# xMCF 3.0.1 document changes

Nick Economidis, BETA-CAE Systems

Figure 23: Screw without nut

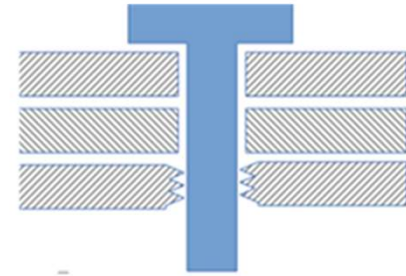
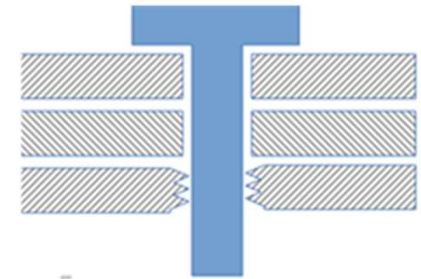
### Bolt vs Screw (Section 7.5.6.1 example 4)

- This was encountered

- <screw>
- No need to mention nut

Do you agree ?

#### Fixed to:
